# Authorized Field Change

**AFC G-01901**

**Subject:** Frame Cracking at the Steer Axle Shock Absorber Bracket Mounting Bolts in the 3000RE Bus Model Built Before January 16, 2001

**Figure 1 Front Shock Absorber Frame Rail Mounting Area Illustrating a Crack as Viewed from Inside the Frame Rail**

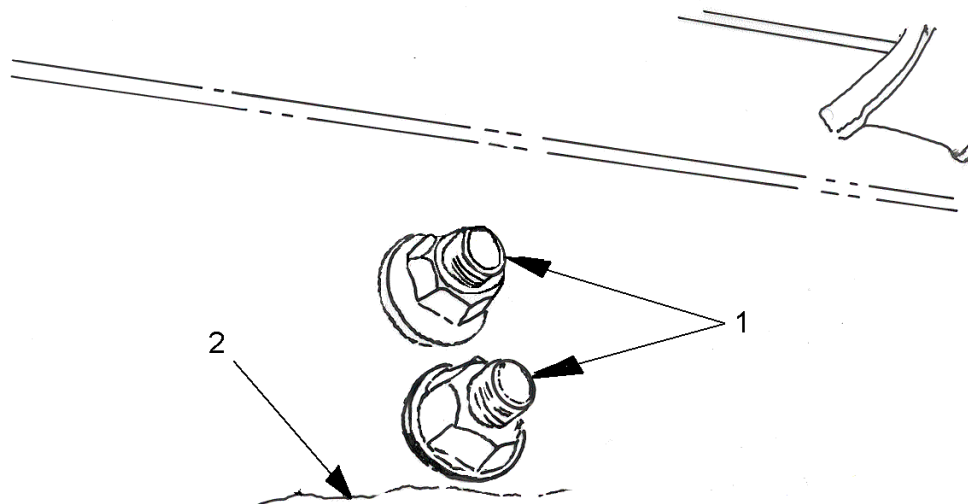
Due to the dynamics of shock absorber forces, the stress levels in the frame web at the steer axle shock absorber bracket mounting bolt locations may exceed the frame material yield strength and may result in cracks as shown in Figure 1. Effective January 16, 2001, a frame reinforcement was implemented in production to address this issue.
